September 29, 2016

Re: Proposed Groundwater Water Recovery System and Supporting Groundwater Model for the FPL Turkey Point power plant facility and Cooling Canal System (CCS) located at, near or in the vicinity of 9700 SW 344 Street, Miami-Dade County, Florida (DERM HWR-821, IW-3 & IW-16).

On May 16, 2016, FPL submitted a three-dimensional, variable density dependent transient groundwater flow and transport Model (the Model) and a proposal for a groundwater recovery well system in fulfillment of paragraph 17.b. of the October 7, 2015 Consent Agreement (CA) between Miami-Dade County and FPL. On May 23, 2016, June 10, 2016, and July 14, 2016, FLP submitted supplemental information in support of the May 16, 2016 submittal.

Figure 3. – Alternative 1: Manual Calibration Simulation for Saltwater-Freshwater and Hypersaline Interfaces at Time = 1 and 10 Years for Model Layer 8

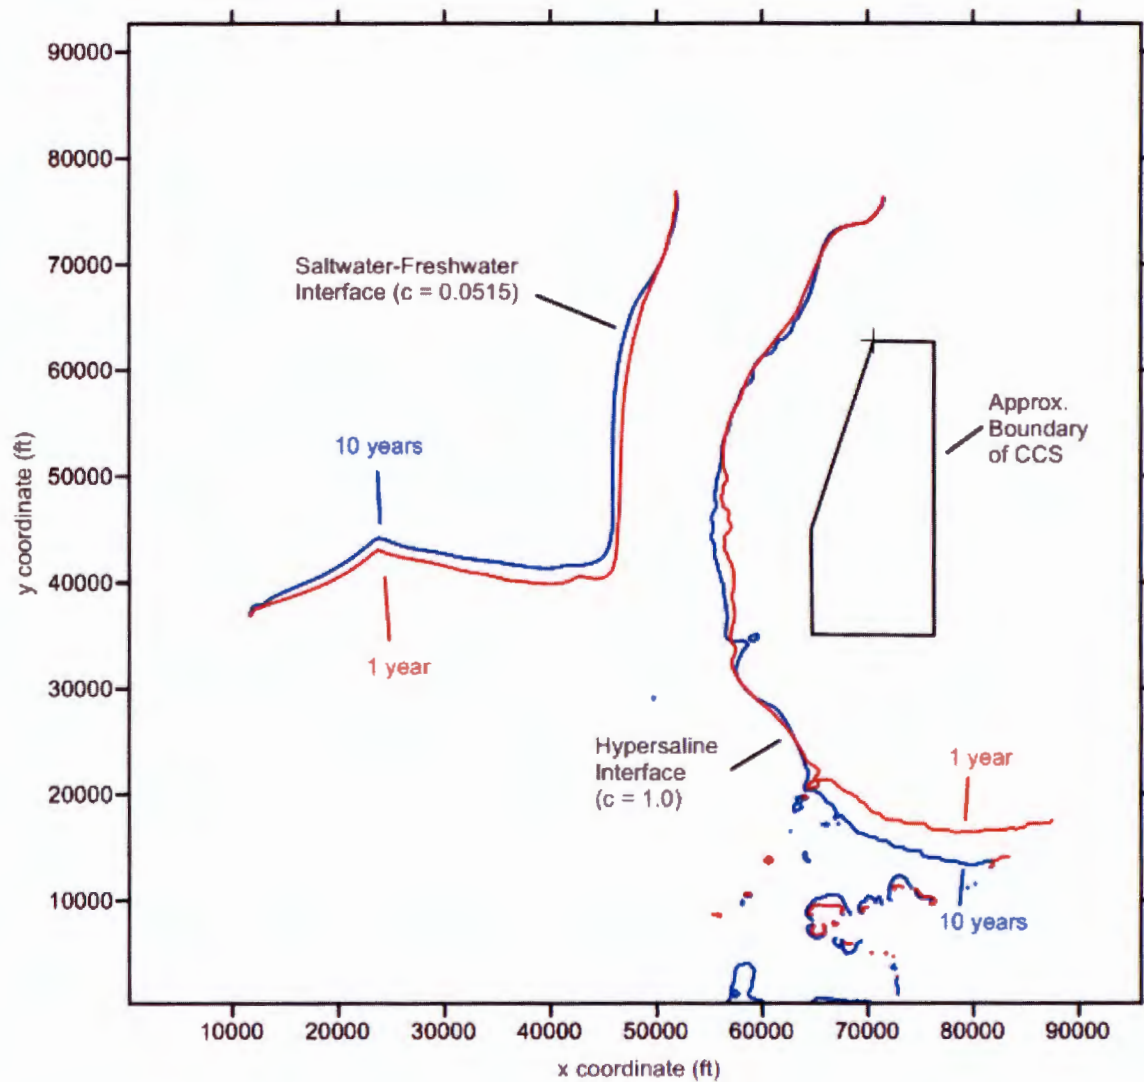
3.2.2.1 Alternative 1 - Alternative 1 is the no-action alternative with no CCS salinity abatement, and the results should indicate what the groundwater model predicts if no remedial action is taken. Using version two of the groundwater model, the maximum concentration of salinity in layer 8 is predicted to increase from $c = 1.840$ at time = 1 year to $c = 1.977$ at time = 10 years (see Figure 3), which is the expected result. However, the hypersaline interface ($c = 1.0$) moves westward a very short, almost imperceptible, distance; similarly, the saltwater-freshwater interface ($c = 0.0286$) moves westward only a very short distance (see Figure 3).

Figure 4. – Alternative 3D: Manual Calibration Simulation for Saltwater-Freshwater and Hypersaline Interfaces at Time = 1 and 10 Years for Model Layer 8

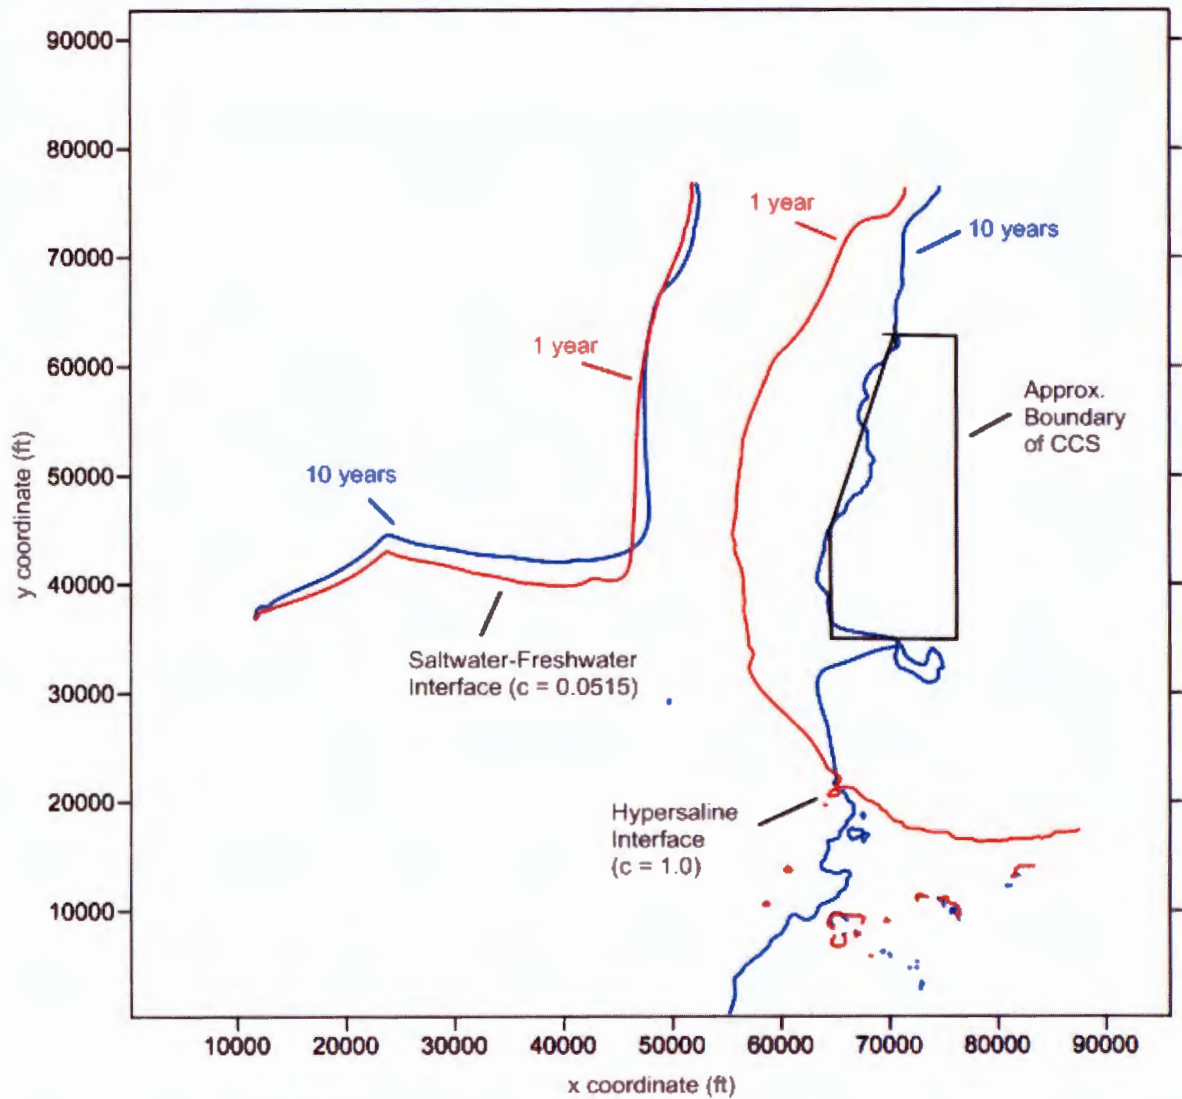
3.2.2.3 Alternative 8 - According to FPL (2016b), the results for Alternative 8, the combined alternative consisting of the extraction wells in Alternative 3D and the injection wells in Alternative 7, indicate that retraction of the hypersaline plume north and west of the CCS is achieved and that the saltwater-freshwater interface is more effectively moved back to the east. A simulation run using the model input files provided for Alternative 8 by FPL on May 15, 2016 confirms that version two of the model predicts the retraction of the hypersaline interface to the western boundary of the CCS in model layer 8 (see Figure 6). However, in this simulation, the location of the saltwater-freshwater interface predicted for Alternative 8 is essentially unchanged from time = 1 year to 10 years in model layer 8 (see Figure 6), and the result is very similar to the result for the saltwater-freshwater interface location in model layer 8 for Alternative 3D, which consists only of extraction wells (see Figure 4).

Figure 7. – Alternative 1: PEST with CSEM Targets Calibration Simulation for Saltwater-Freshwater and Hypersaline Interfaces at Time = 1 and 10 Years for Model Layer 8

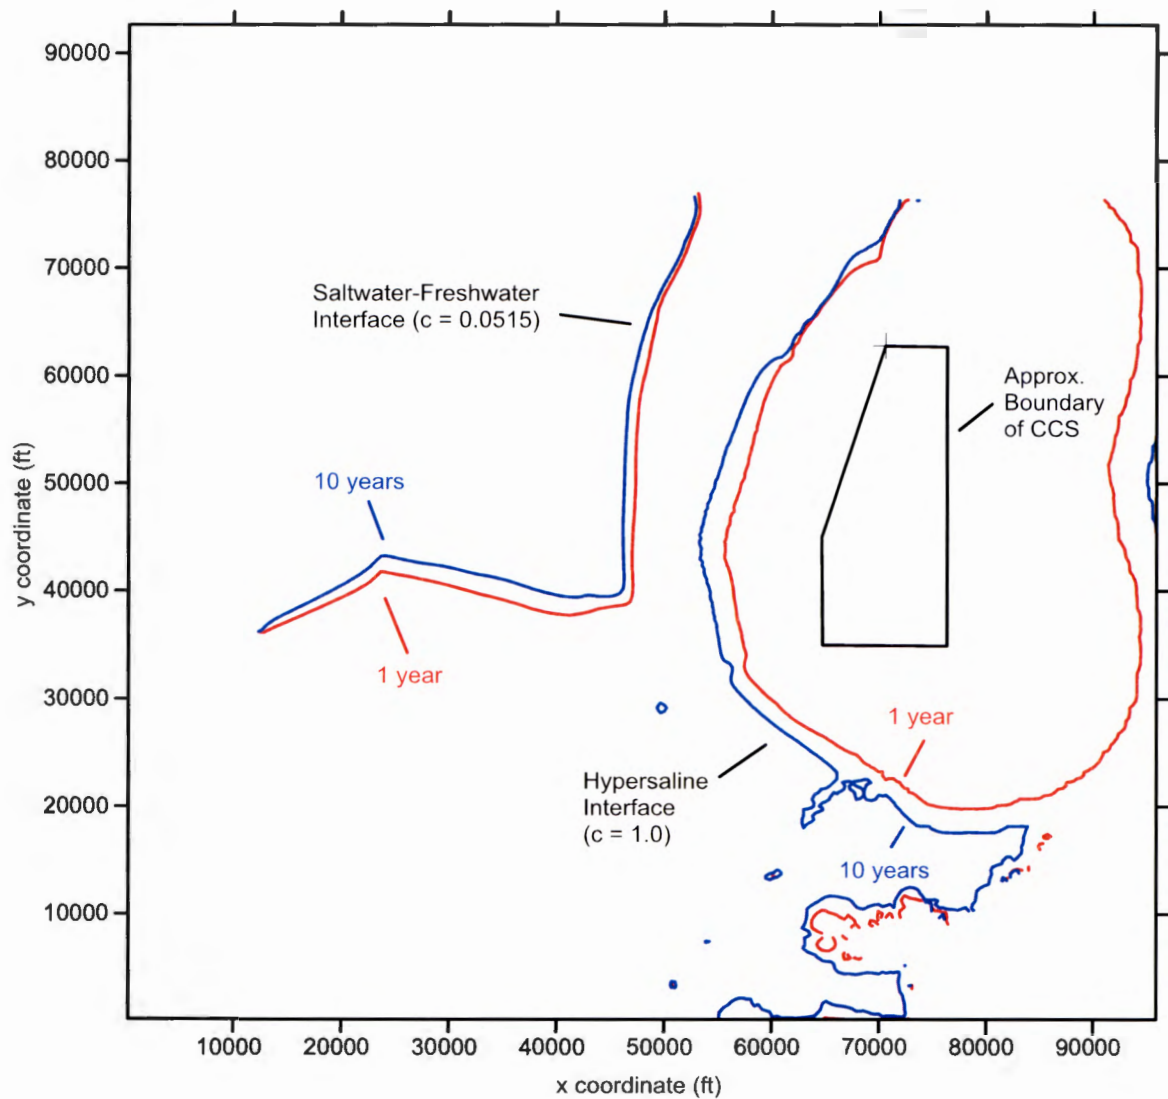
3.2.3.1 Alternative 1 - The results obtained for alternative 1, the no-action alternative, using version four of the groundwater model are similar to the results obtained using version two of the model. The maximum concentration of salinity in layer 8 is predicted to increase from $c = 1.840$ at time = 1 year to $c = 1.977$ at time = 10 years (see Figure 7), but the hypersaline interface ($c = 1.0$) and the saltwater-freshwater interface ($c = 0.0515$) move westward only short, almost imperceptible, distances (see Figure 7).

Figure 9. – Alternative 3D: PEST with CSEM Targets Calibration Simulation for Saltwater-Freshwater and Hypersaline Interfaces at Time = 1 and 10 Years for Model Layer 11

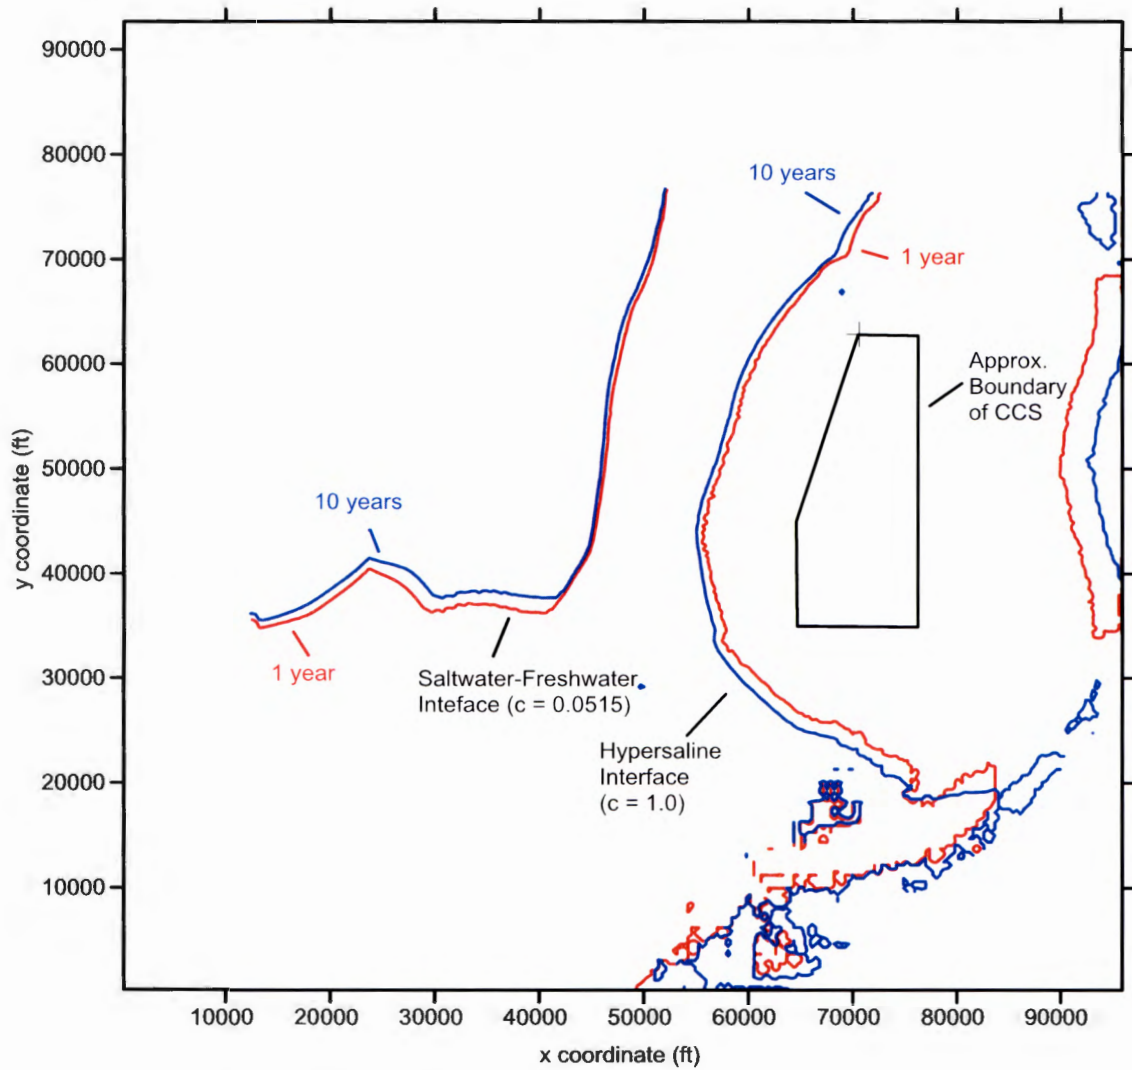
3.2.3.2 Alternative 3D - For alternative 3D, the simulation performed using version four of the model is similar to the results obtained using version two. This simulation confirms Tetra Tech's model prediction that the hypersaline interface is moved eastward to the western boundary of the CCS at the end of the 10-year simulation (see Figure 8). Also, similar to what is reported by Tetra Tech (2016c), this version of the model predicts that the hypersaline interface in the lower zone (model layer 11) does not respond to Alternative 3D and remains essentially in the same location after 10 years (see Figure 9).

Seasonal Model: Net Recharge at R155 C21

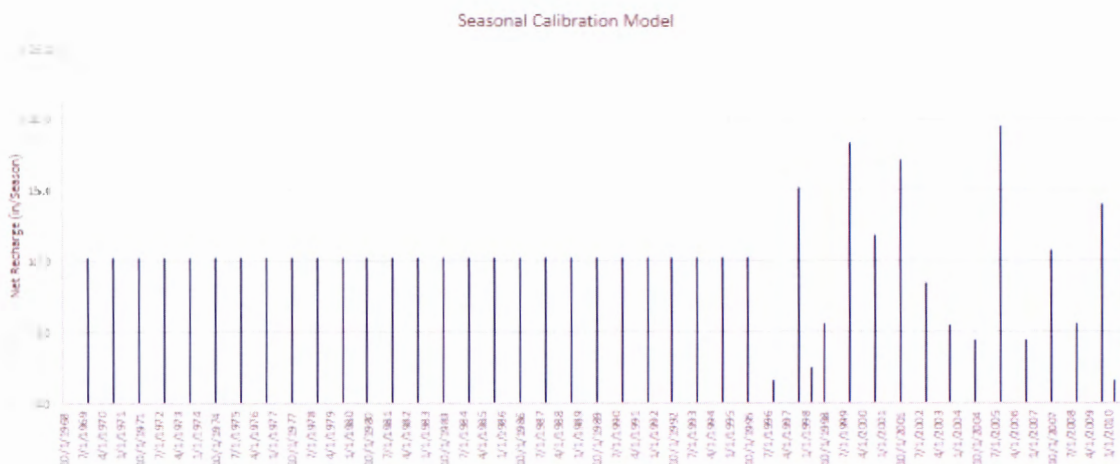
Figure 1 shows the net recharge applied in each stress period or season in the model at a selected location (R255 C21). It indicates that the most recharge occurs during the wet seasons as expected. A recharge of 10 inches per year in the wet season is applied uniformly from 1968 to 1995 whereas variable recharge rates are applied from 1996 through 2010 including net recharge being applied during the dry season in certain years. The technical memorandum does not indicate why the recharge rates were varied. Presumably, the change could be part of the calibration process. However, it is not clear why the recharge from 1968 to 1995 are uniform or why the change was made for years after 1995.

Figure 2. Dry cells in model Layer 1 at the end of stress period 1 in the monthly calibration model.

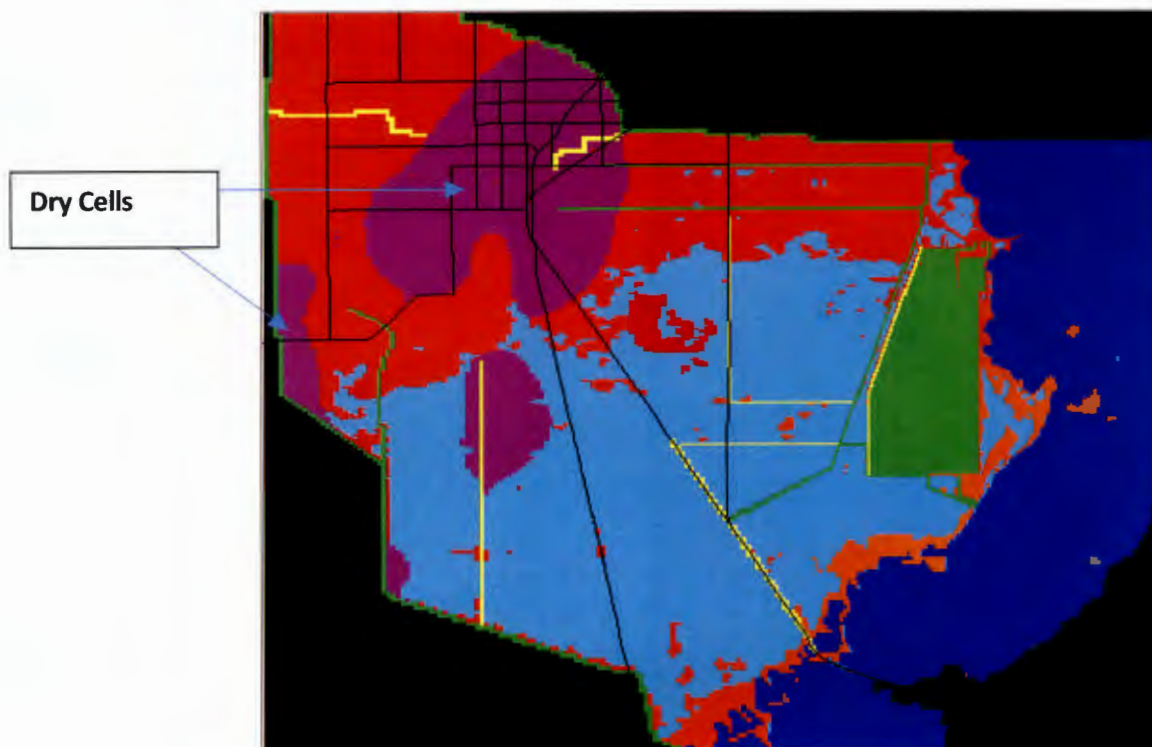
Table 1 shows the heads and bottom elevations at two cells located at the active-dry cell border at the end of stress period 1 in the monthly calibration model. In MODFLOW, a cell becomes dry when the simulated water level in the cell is below the layer bottom elevation. Simulated water levels drop from 0.929 feet at cell R55 C22 to a value below -0.758 foot at the adjacent cell (R55 C23) compared to the head change (0.05 feet) in underlying Layer 2.

Figure 3. Simulated water levels (ft, NGVD) for December 2015, in Layer 8.

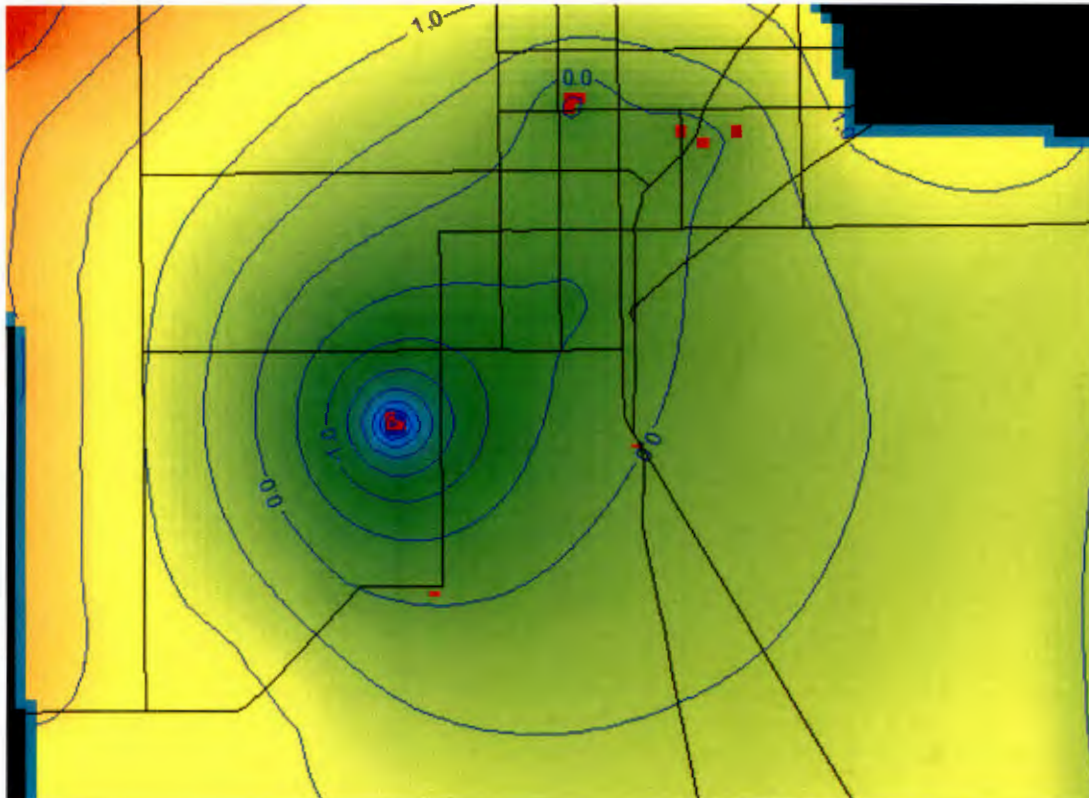
The model results also show a large area of drawdown due to withdrawals from the FKAA wellfield (Figure 3). Such a large extent of cone of depression is not consistent with field measurements and likely represents an inaccurate simulation of the wellfield influence in an area of extremely high transmissivity. The effect of model boundary interference with wellfield drawdown may also be indicated.

Figure 4. Net recharge (inches/season) applied in monthly calibration model.

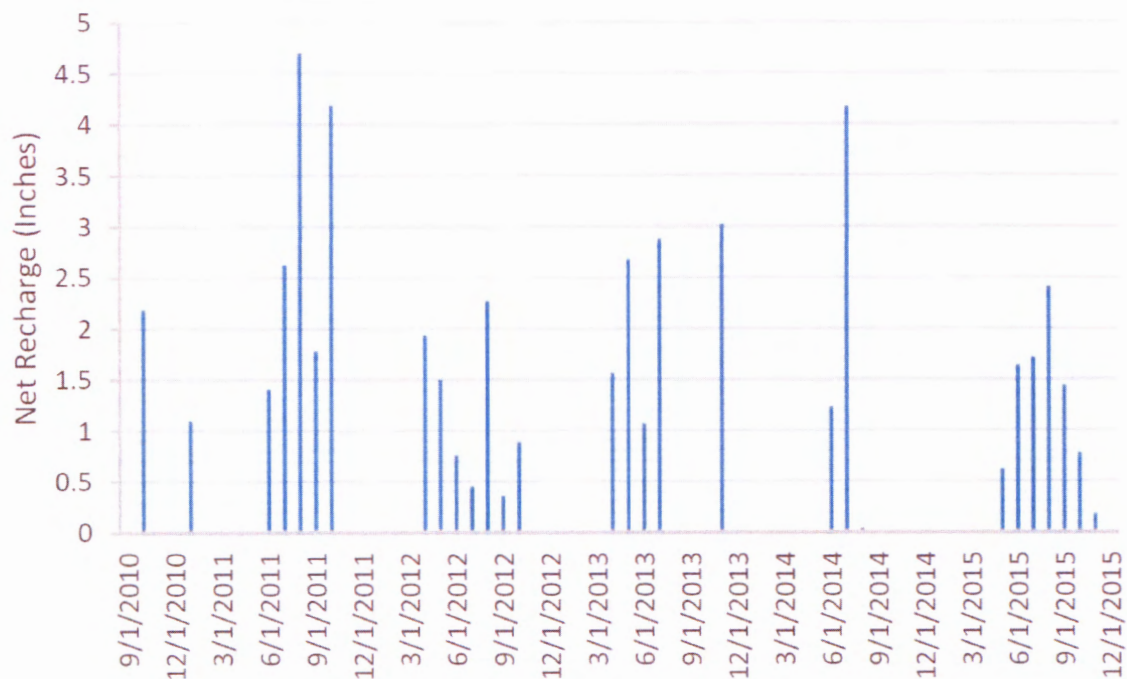
In addition to the dry cells, the model results also showed large areas where the cells were “flooded” when calculated water levels were above the land surface. The flooded cells may be caused by inadequately accounting for evapotranspiration in the model’s “net recharge” approach or by using non-representative hydraulic parameters in the shallow layers. Monthly net recharge rates at a selected location (R155 C21) are presented on Figure 4.

Figure 8. Performance of individual extraction wells in ALT3D (near UIC well is not shown).

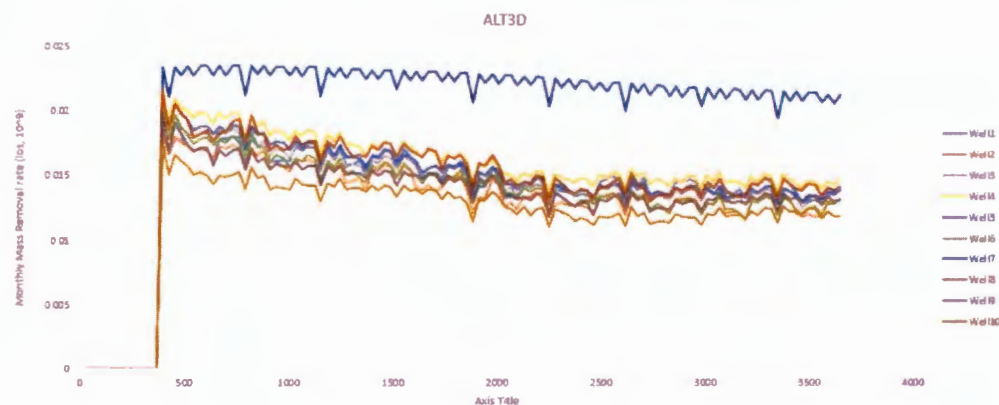
It would be of interest to see if a higher efficiency of extraction of the hypersaline plume and seaward movement of the saline water interface could be achieved with the location of the extraction wells more towards the middle of the hypersaline plume. It would also be beneficial to look at the mass removal rate of each extraction well, as shown in Figure 8 for ALT3D, to optimize the remediation system design.

Figure 11. Simulated head changes in model Layers 1-4 in seasonal calibration model.

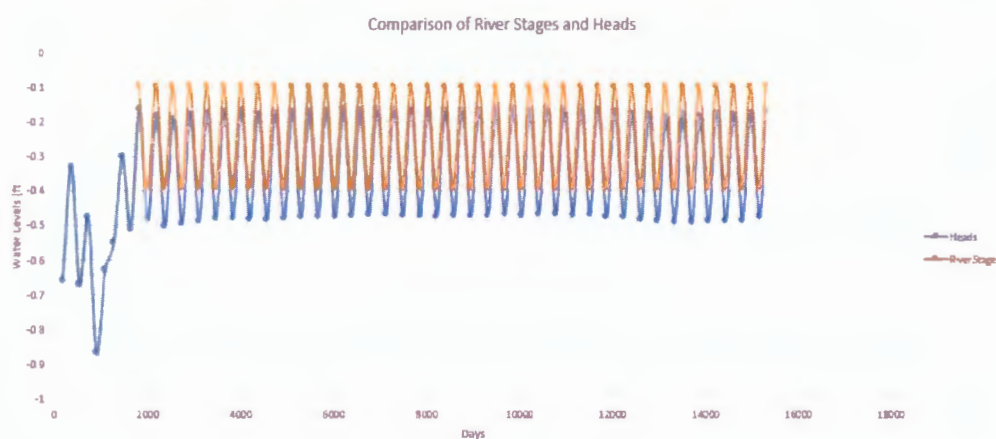
Layers 1 through 11 are hydraulically well connected and water levels in these layers fluctuate in a similar fashion. As indicated on Figure 11, a slight offset of about 0.05 feet is noted between the simulated water level in Layer 1 and stage values in the canal. The salinity in the aquifer is also very similar to the salinity specified in the CCS at the selected location as indicated on Figures 14 and 15.

Figure 15. Simulated salt concentration changes in model Layers 5, 7, 9, and 11 in the seasonal calibration model.

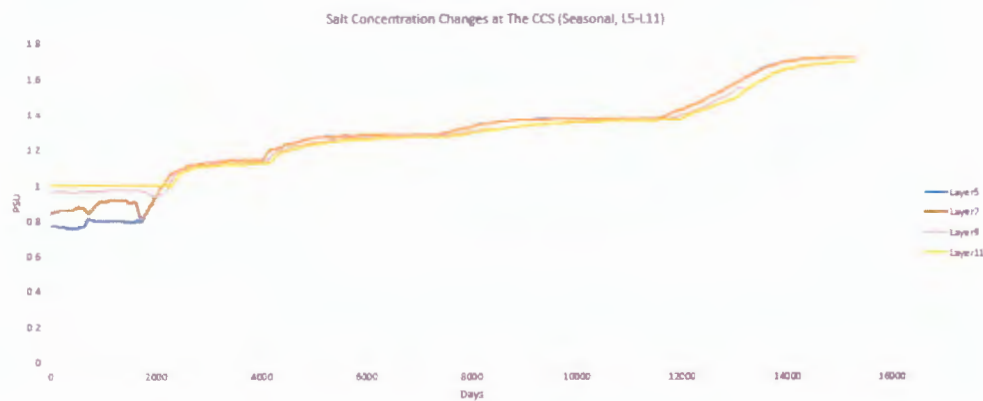
As shown on Figure 15, the maximum salinity in the CCS simulated in the seasonal model is about 1.8 PSU. It is relevant to note that salinity as high as 3.0 PSU has been reported for CCS (Chin, 2015). Higher salinity, up to about 2.7 PSU as shown in Figure 17, was applied to the CCS in the monthly model. However, due to change in canal conductance at that time, the salinity in deeper layers appears to not be impacted by the salinity in the CCS. It needs to be understood why the simulated salinity does not match the observed peak salinity values in the canal and how the low conductance in canal post 2013 is affecting the salinity in lower model layers.
